Technical Service Information

FORD 4R100 "NON-PTO" AND "PTO" HYDRAULIC DIFFERENCES

CHANGE: Beginning at the start of production for 1999 models, Ford Motor Company made available a "Power Take Off" option for some F250, F350, F450 and F550 Super Duty Trucks, equipped with 5.4L, 6.8L and 7.3L engines.

Figure 7

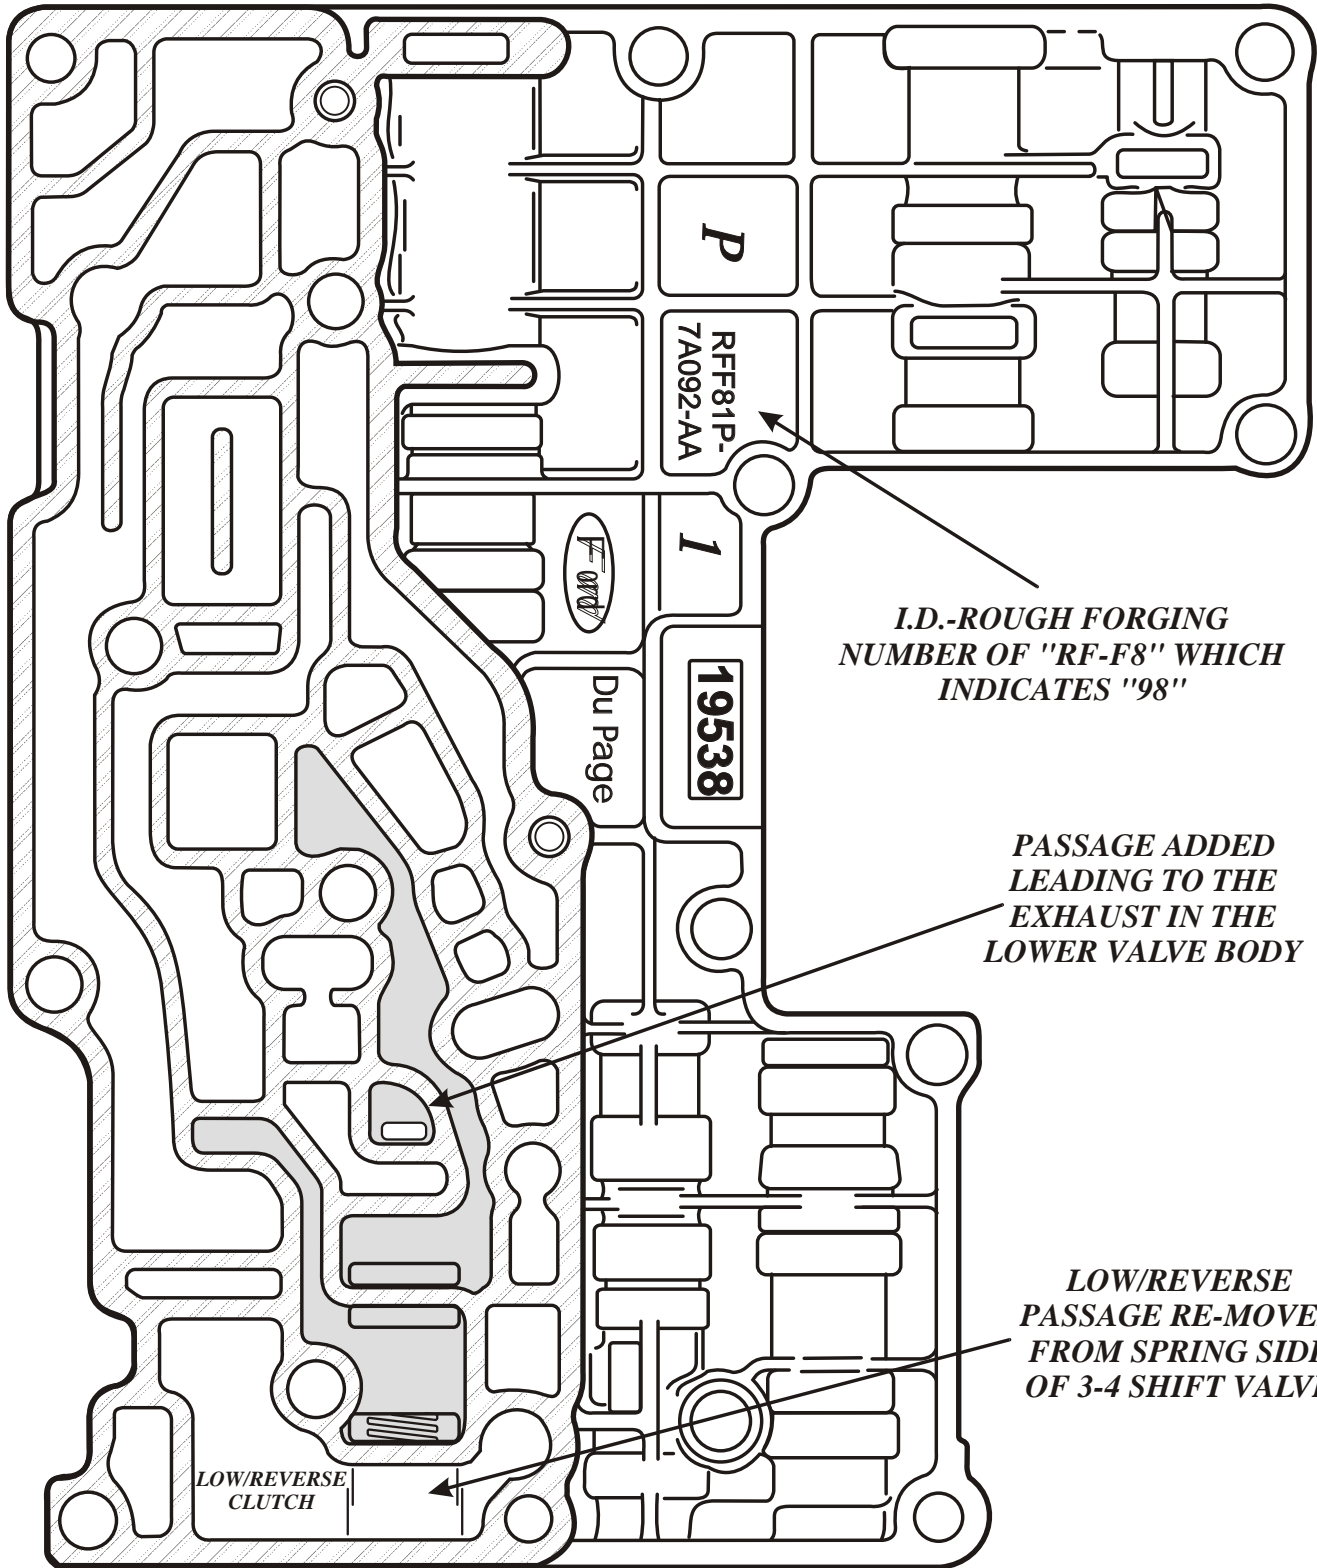
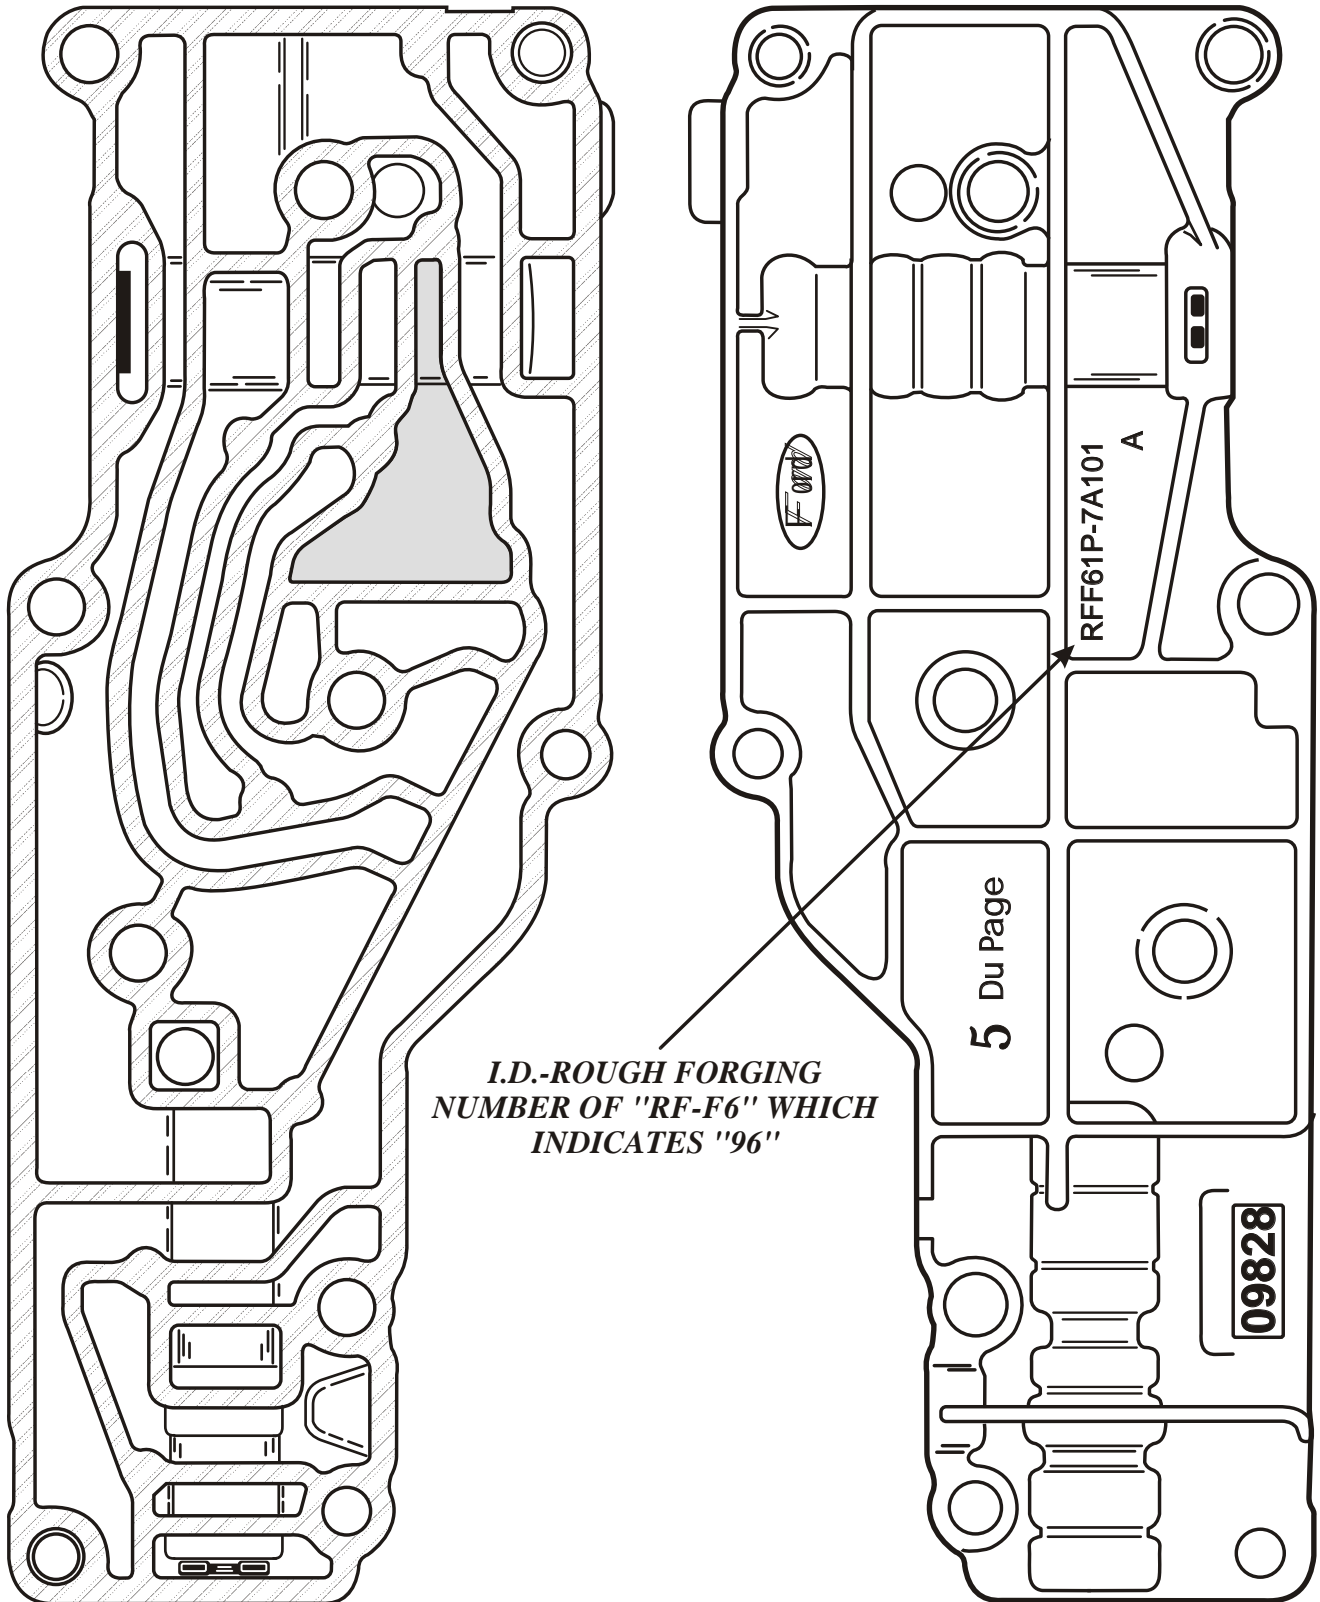
- (3) **MAIN VALVE BODY:** A passage was added on the "Upper Side" of the Main Valve Body on "PTO" versions, as shown in Figure 5, to supply Line Pressure to the 3-4 Shift Valve. A passage was also added, on the "Lower Side" of the Main Valve Body, to connect the 3-4 Shift Valve (Coast Clutch Circuit) to an exhaust as shown in Figure 7. The spring side of the 3-4 Shift Valve was also separated from the Low/Reverse circuit as shown in Figure 7. Refer to Figures 4-7 for identification of "NON-PTO" and "PTO" Main Valvebody's.

Figure 9

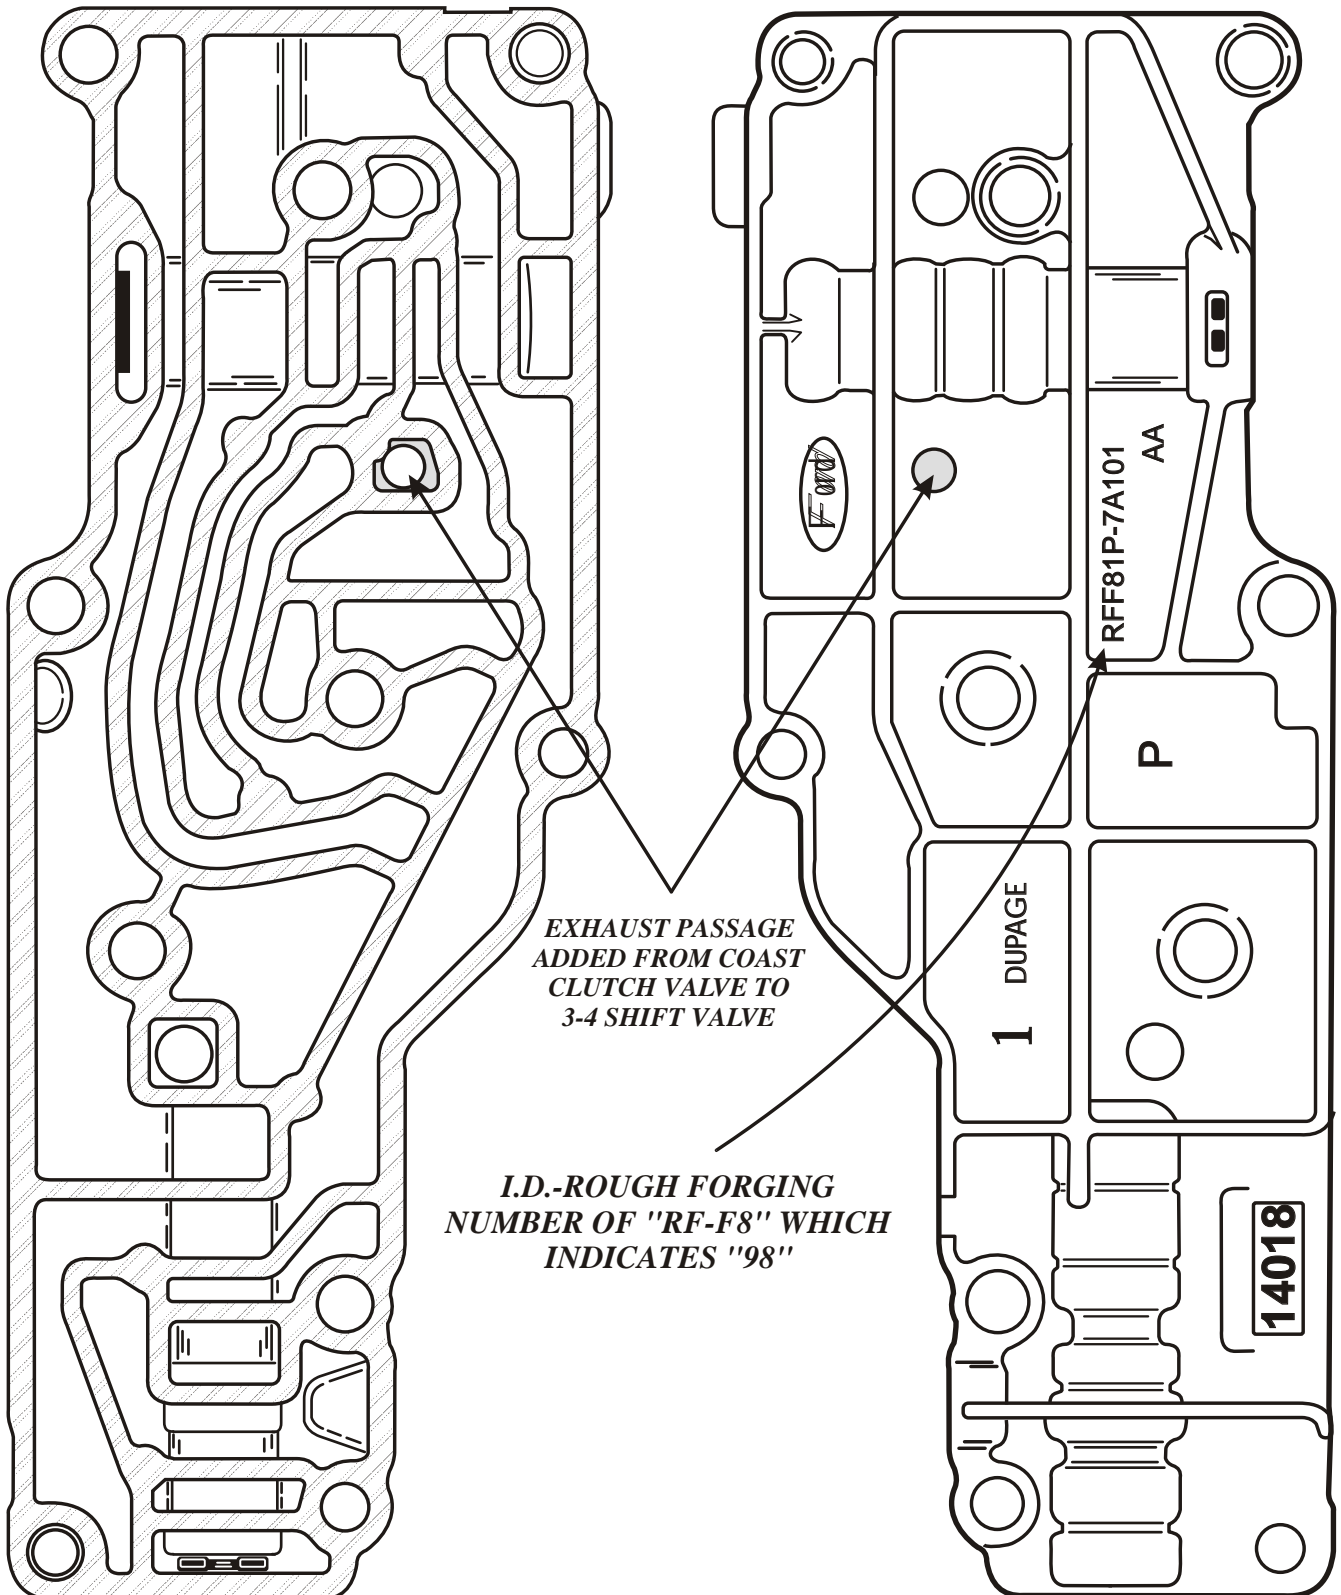
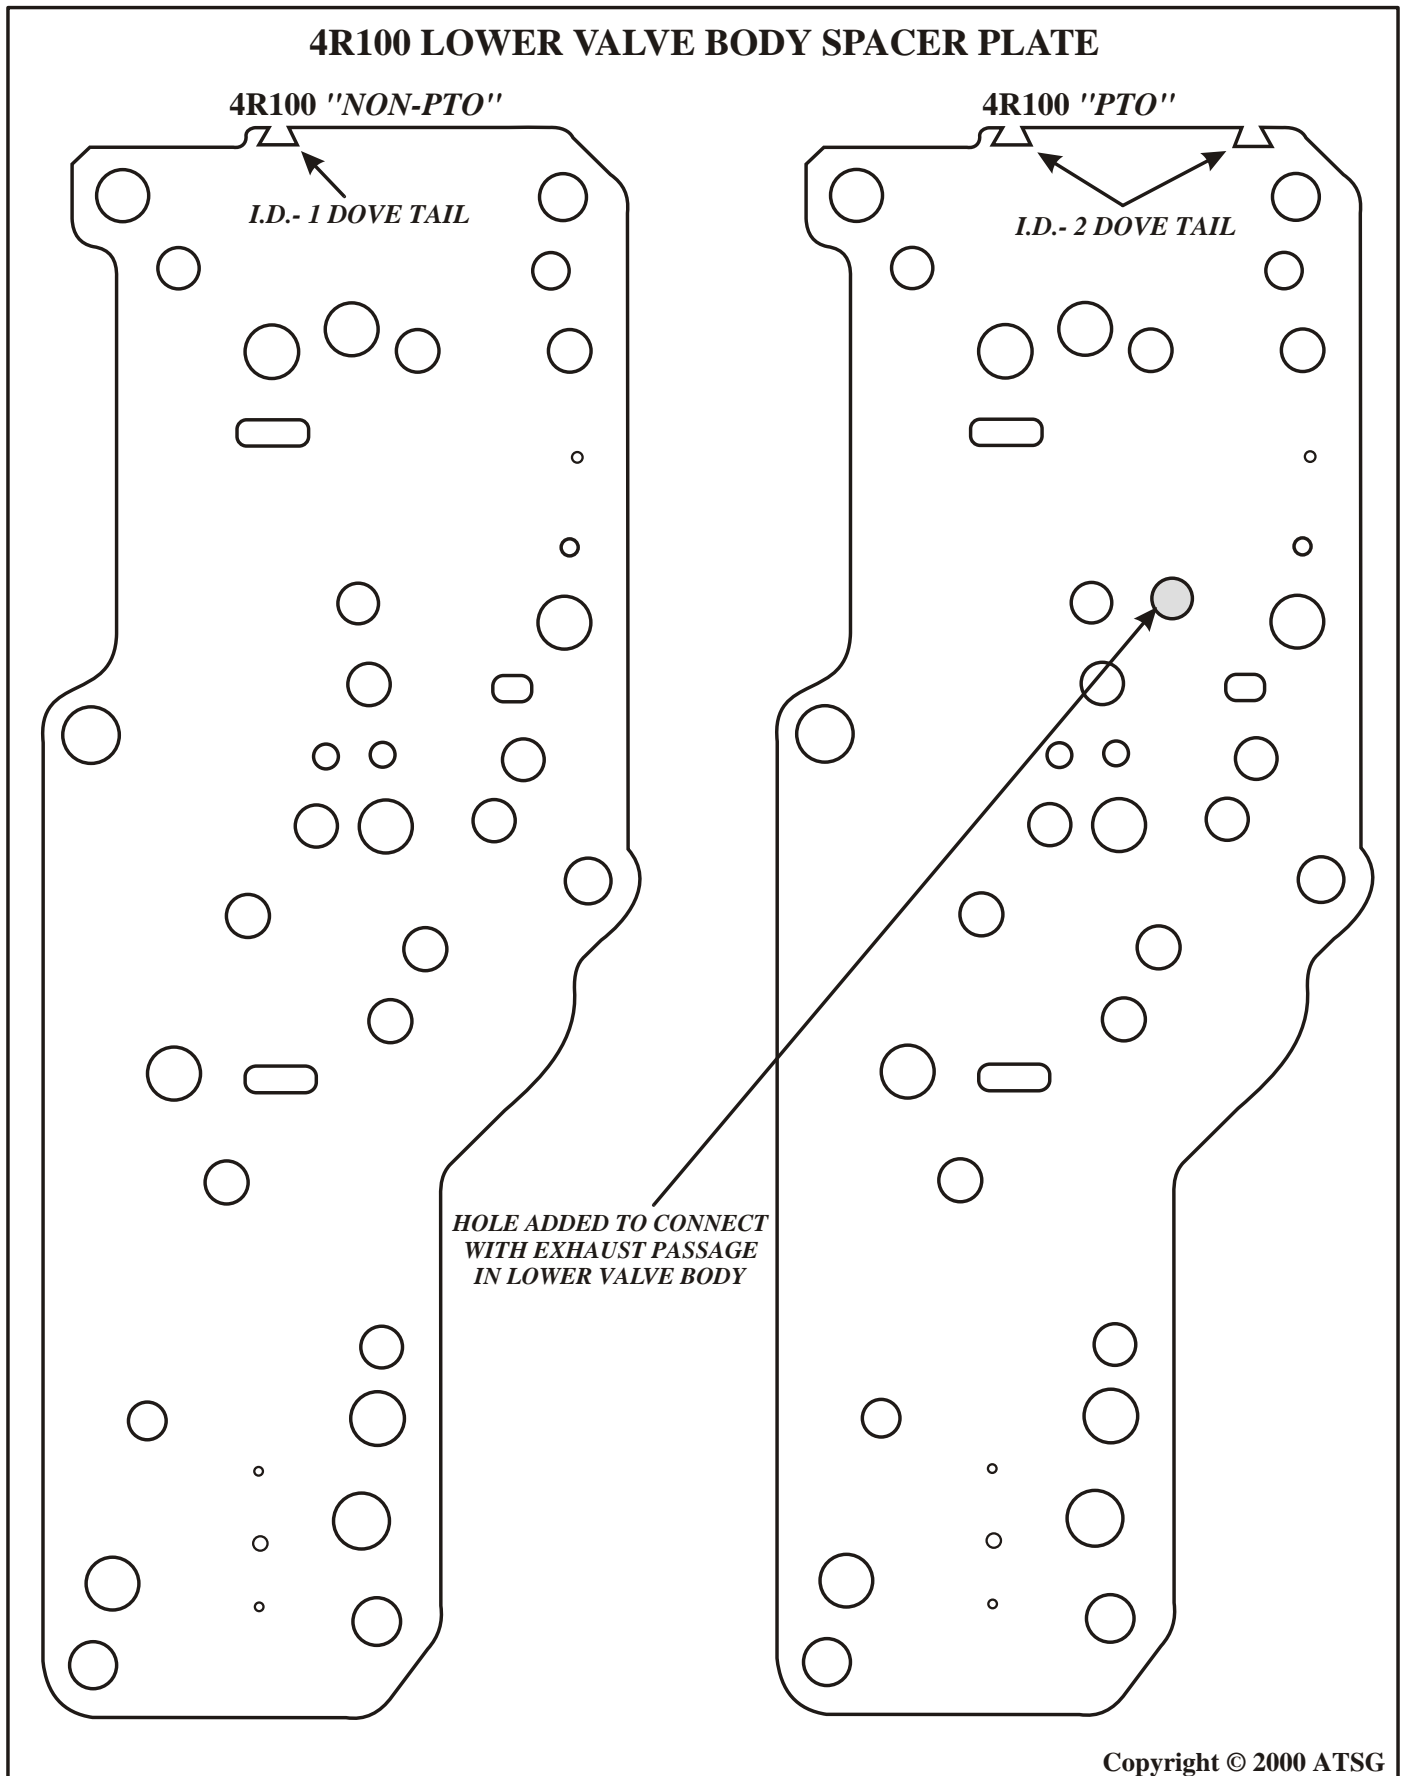
- (4) **LOWER VALVE BODY:** The Lower Valve Body had a passage added, as shown in Figure 9, to connect to the "*new*" exhaust passage in the Main Valve Body. Refer to Figures 8 and 9 for identification of "NON-PTO" and "PTO" Lower Valvebody's.

Figure 10

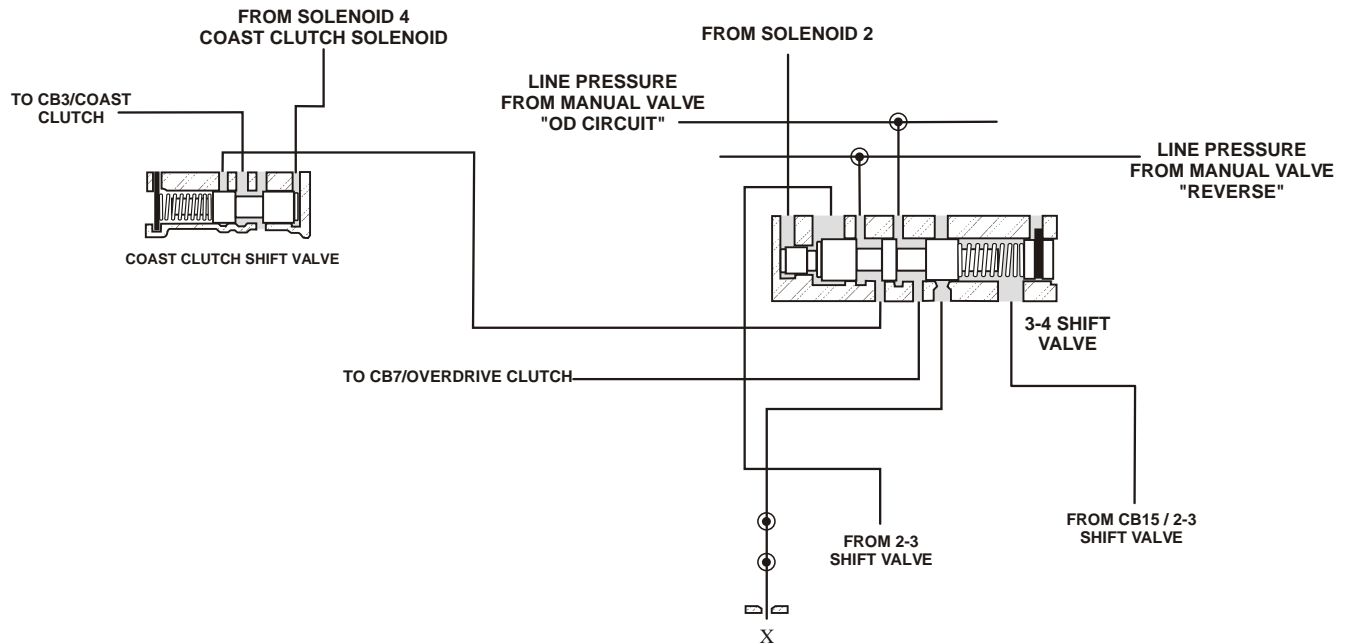
- (5) **LOWER VALVE BODY SPACER PLATE:** The Lower Valve Body Spacer Plate had a hole added to connect the "*new*" exhaust passage in the Main Valve Body to the "*new*" exhaust passage in the Lower Valve body as shown in Figure 10. Refer to Figure 10 for "NON-PTO" and "PTO" Lower Valve Body Spacer Plate identification.
